ADDENDUM NO.: 01
PROJECT NAME: DUNNE TECHNOLOGY ACADEMY MODERNIZATION
PROJECT NO.: 05440
CONTRACT NO.: C1566
DATE OF ISSUE: February 27, 2015

NOTICE OF CHANGES, MODIFICATIONS, OR CLARIFICATIONS TO CONTRACT DOCUMENTS

PROJECT DUNNE TECHNOLOGY ACADEMY MODERNIZATION		TITLE REVISE NOTE 7, DETAIL #5	
FGM ARCHITECTS <small>CHICAGO OAK BROOK OFALLON ST. LOUIS</small>	DRAWN Author	DATE 02/26/2015	SHEET NO. CSK-001
	APPROVED Approver	JOB NO. 15-1950.01	ISSUED AS ADD #1
PROFESSIONAL DESIGN FIRM - IL # 184-000350

SITE UTILITY PLAN
 Sheet
C1.4.1

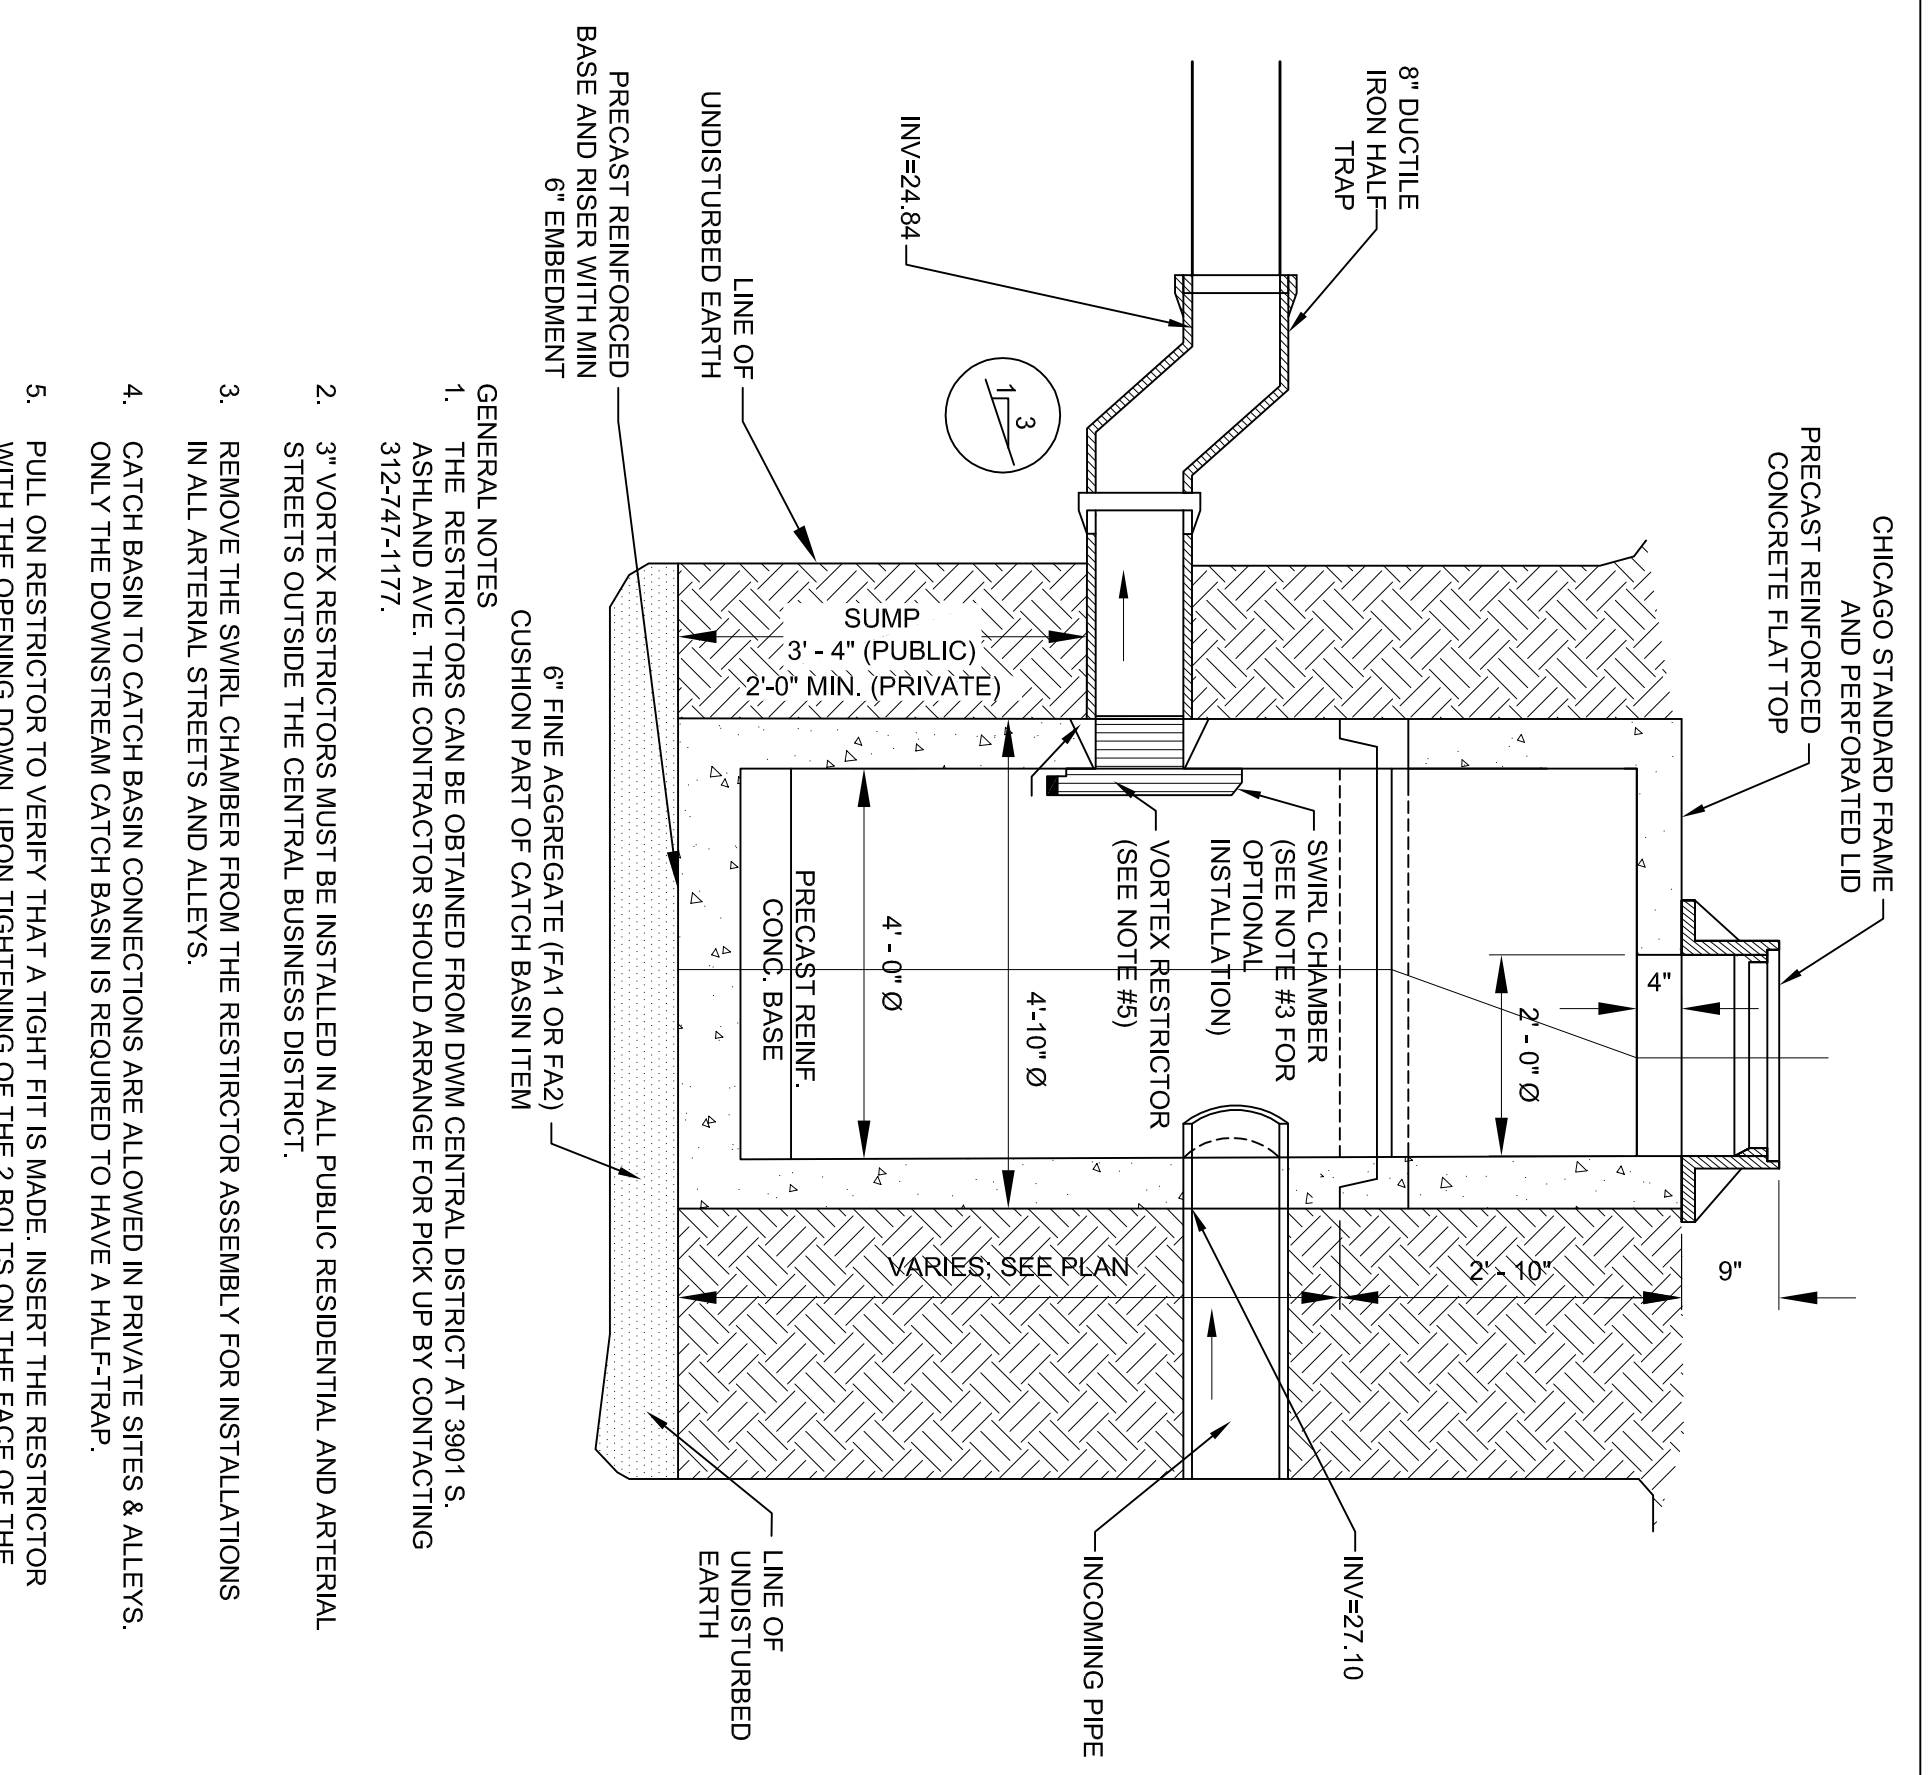
1. SHEET C1.4.1 – SITE UTILITY PLAN
 - a. Revised storm sewer from 24" diameter to 36" diameter from CB-5 to CB-6
 - b. Revised inverts from Storm Service at building, CB-1 and CB-2 as indicated on the drawing.
 - c. Revised trench widths as indicated on the drawing.
2. SHEET C1.5.1 – SITE DETAILS (Refer to CSK-001)
 - a. Revise detail #5, note 7.
3. SHEET C1.5.2 – UTILITY DETAILS
 - a. Revise detail #11, cross-section trench storage widths as indicated on plan.
 - b. Update Turf Field detention cross-section per new trench dimension as shown on C1.4.1
4. SHEET C1.5.1 – SITE DETAILS
 - a. DETAIL 10A – Should read "FUEL EFFICIENT AND LOW-EMITTING VEHICLES ONLY" in lieu of, "FUEL EFFICIENT ONLY".
 - b. TAG 10B – Should read "CARPOOL DROP OFF ZONE" in lieu of, "CARPOOL PARKING ONLY".

Title
FIRST FLOOR PLAN

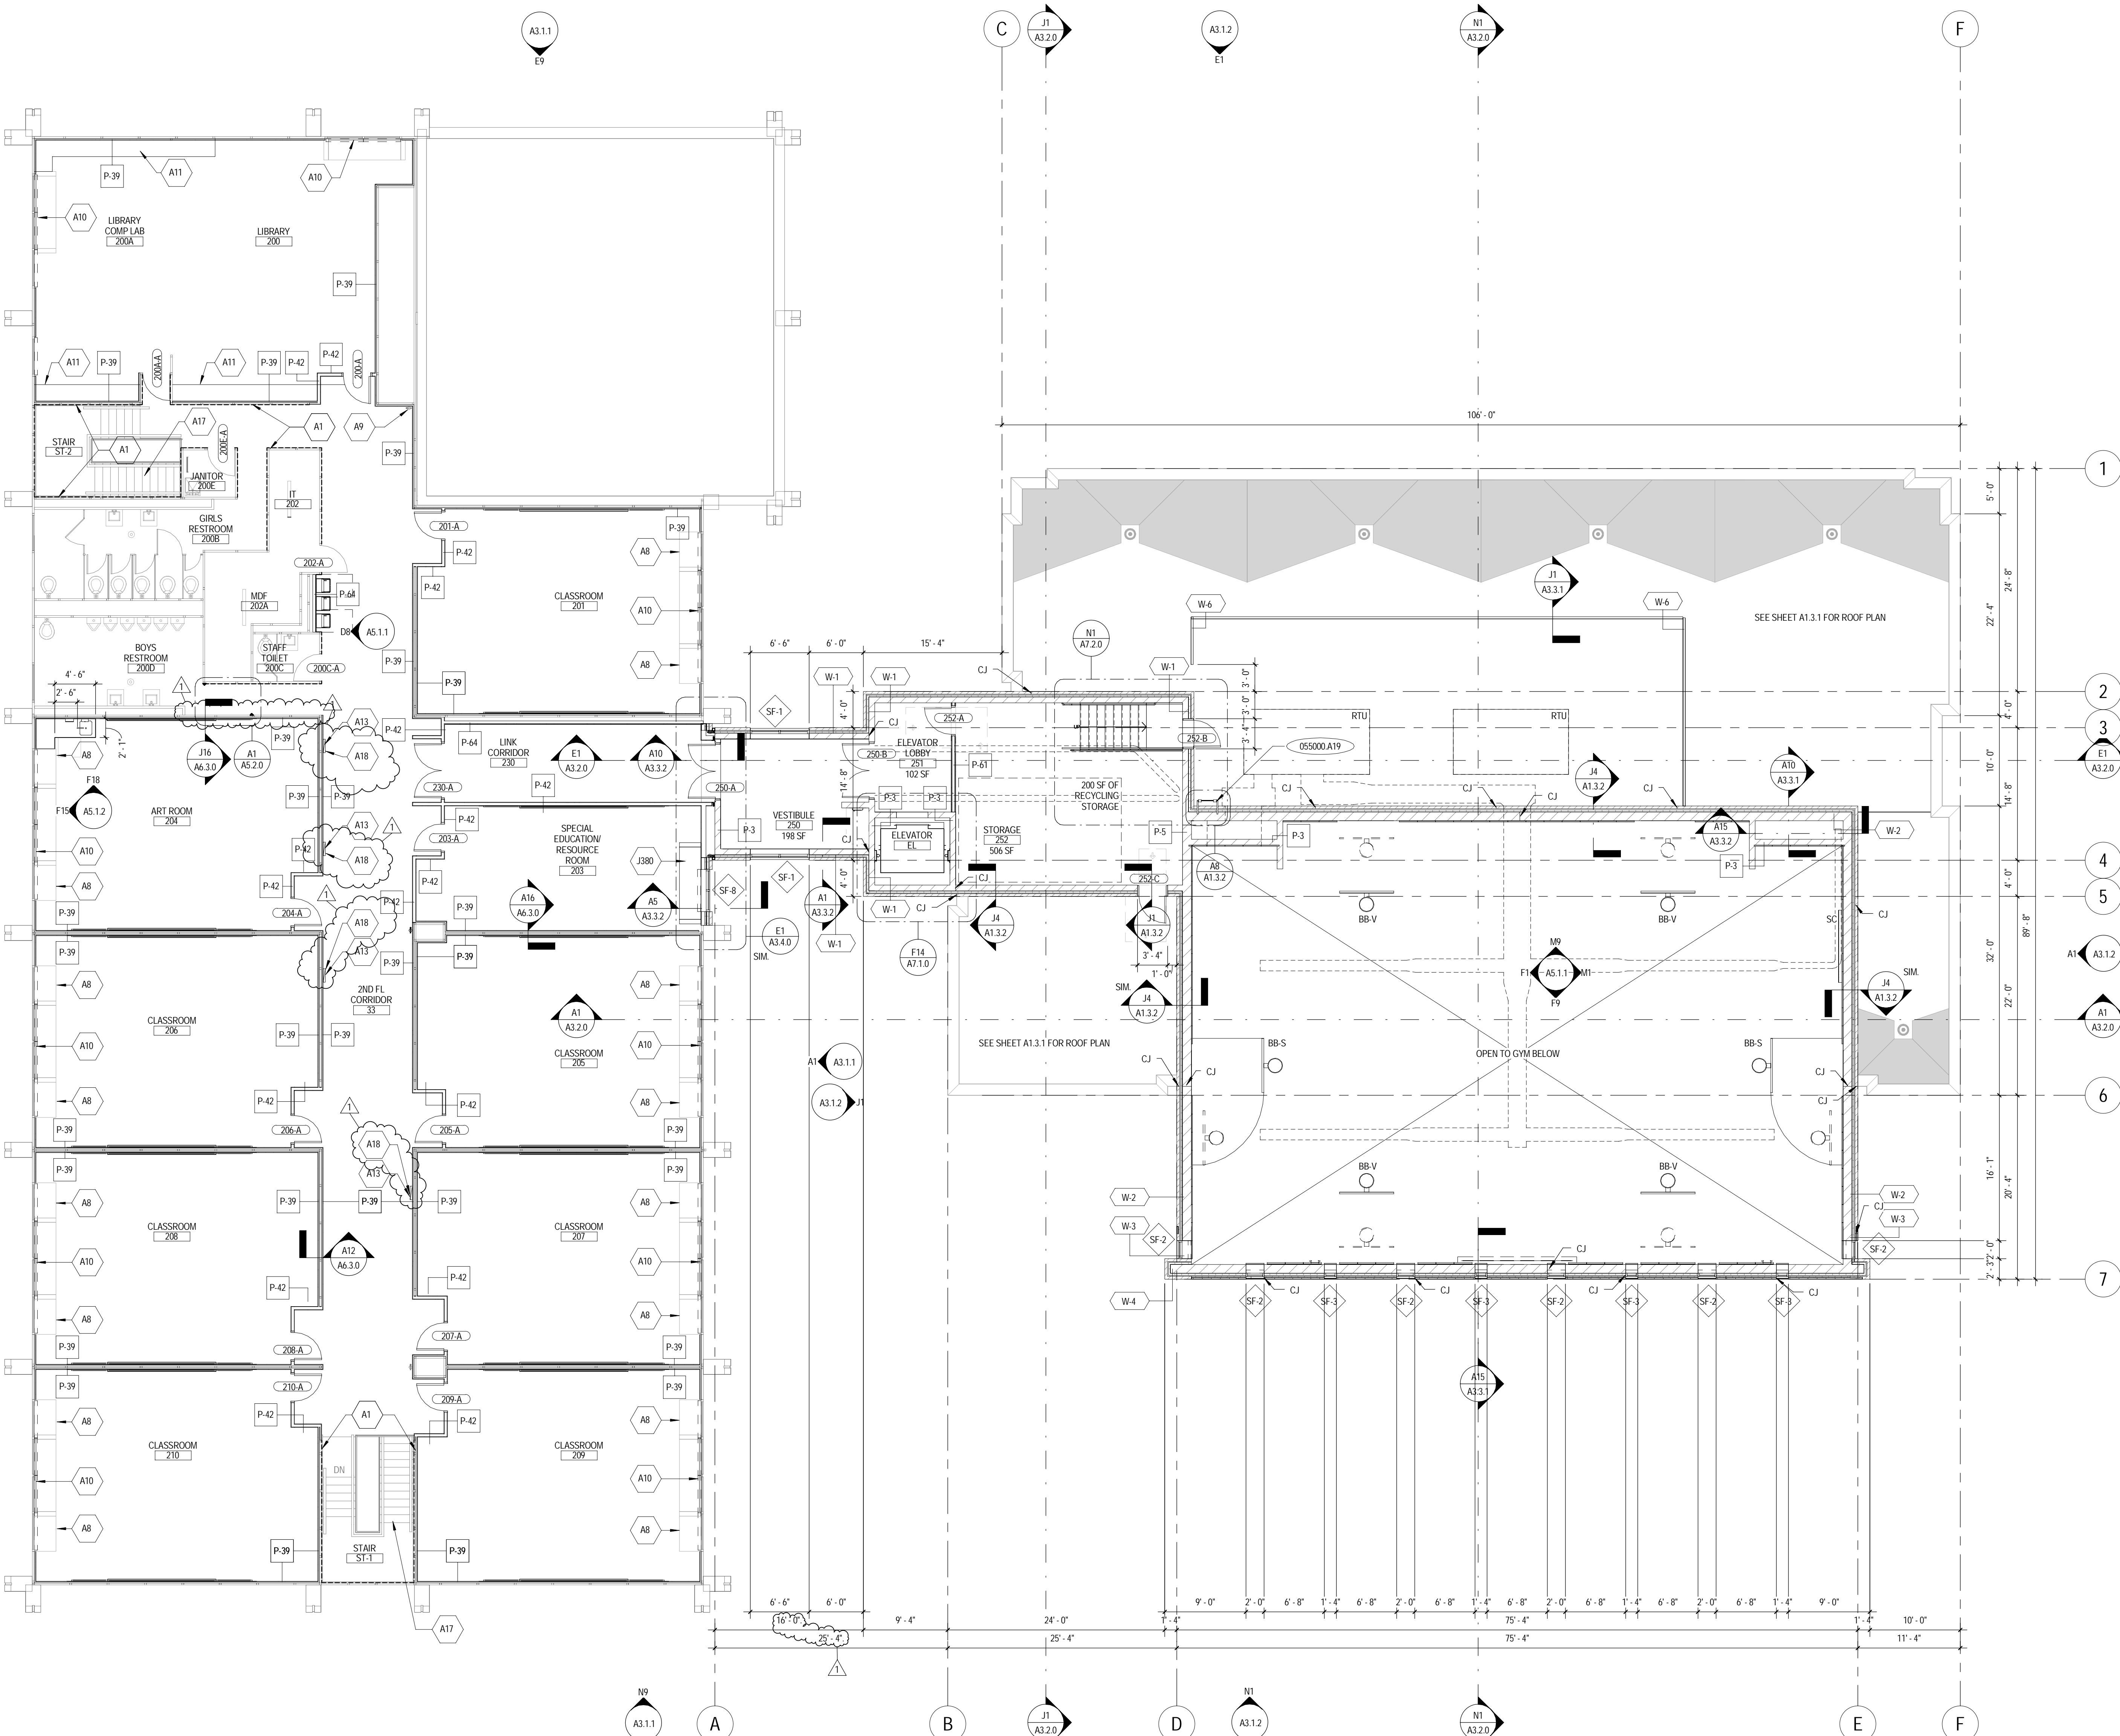
- a. Added Note A18 to read as follows: "ELECTRICAL PANEL CHASES TO BE PAINTED."
 - b. Revised various plan dimensions to match the structural drawings.

Title
SECOND FLOOR PLAN

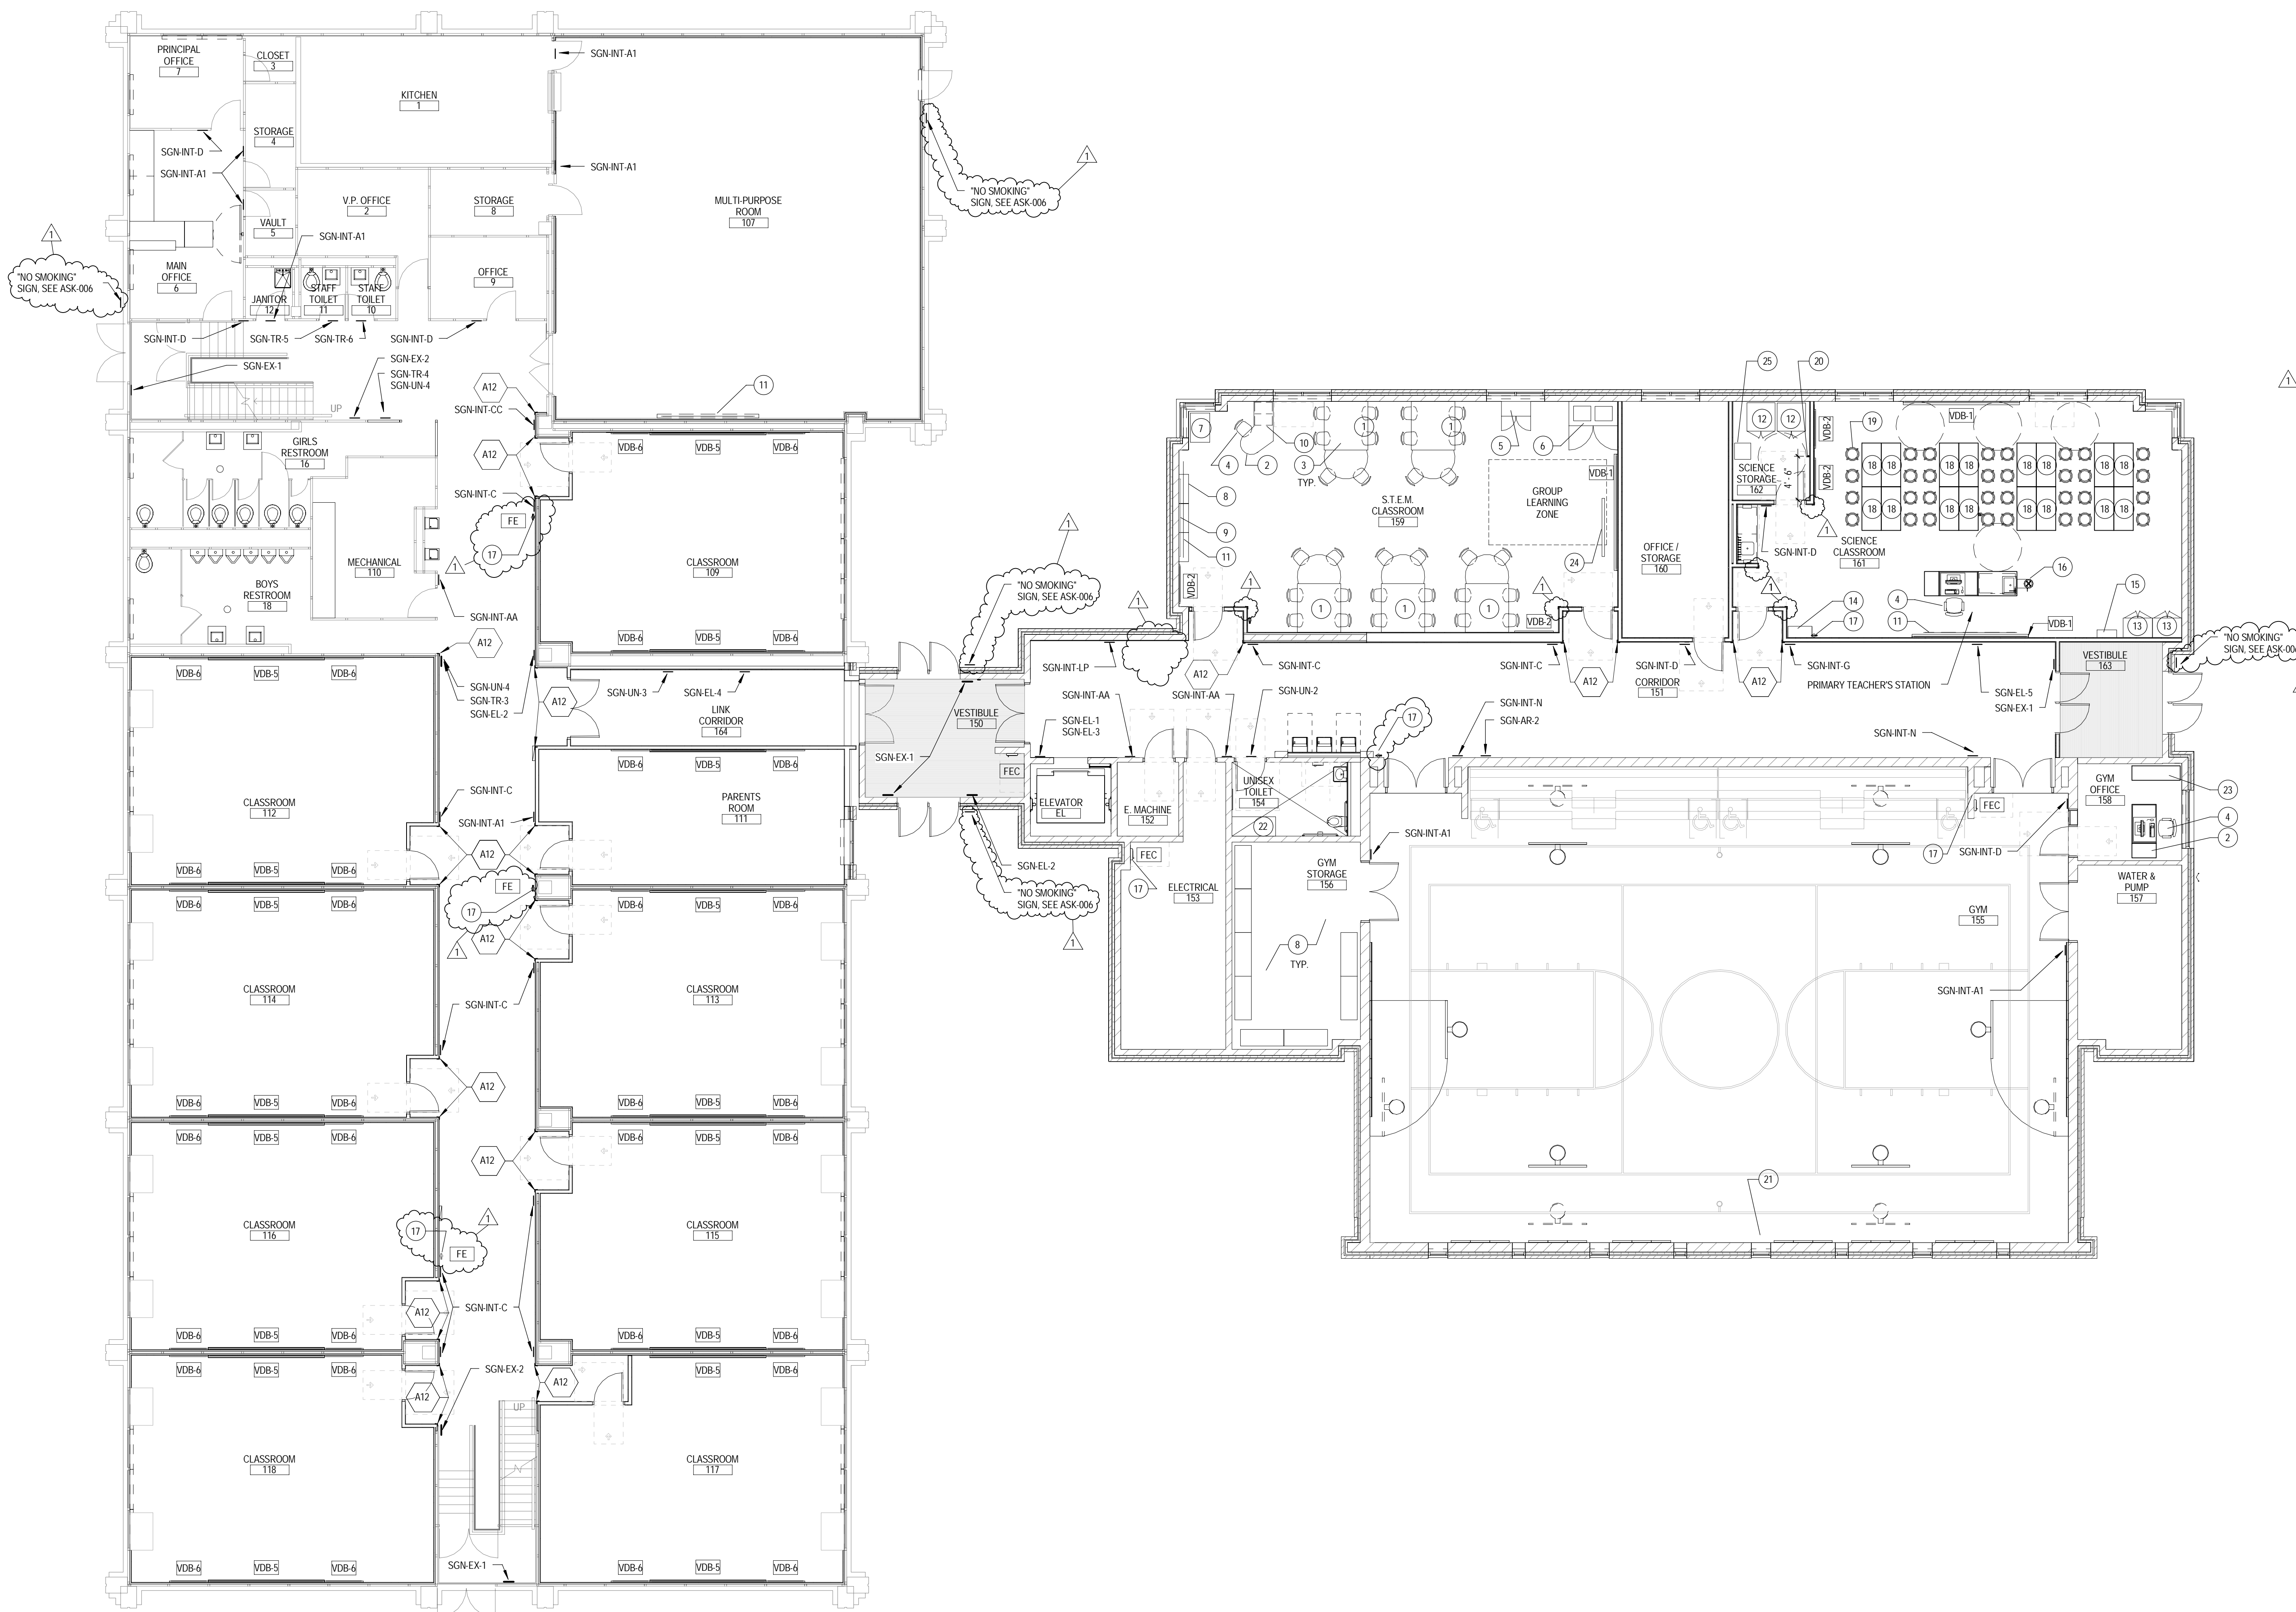
7. SHEET A1.2.0 – SECOND FLOOR PLAN
 - a. Added Note A18 to read as follows: "ELECTRICAL PANEL CHASES TO BE PAINTED."
 - b. Revised various plan dimensions to match the structural drawings.
